TEMPORARY CHANGE NOTICE REQUEST FORM

TCN NO. 00-0286

1. PROCEDURE NUMBER EIP-ZZ-03010 REVISION NO. 007

PROCEDURE TITLE Hazardous Chemical/Oil Spill Response/Spill Cleanup Implementing Procedure

# HAZMAT SHEET

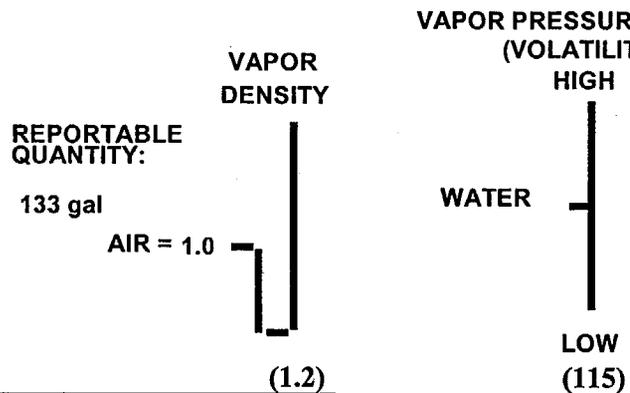
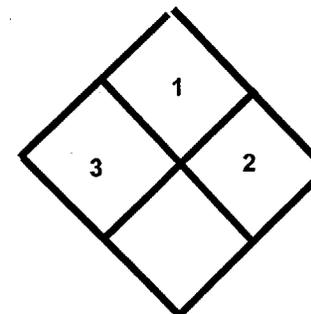
2.1 PAGE NUMBERS AFFECTED BY CHANGE Added page 2a of 2 to Attachment 2

2.2 CHANGE SUMMARY Added Hazmat Sheet for Ammonium Hydroxide (30%)/Change to Secondary pH control chemicals
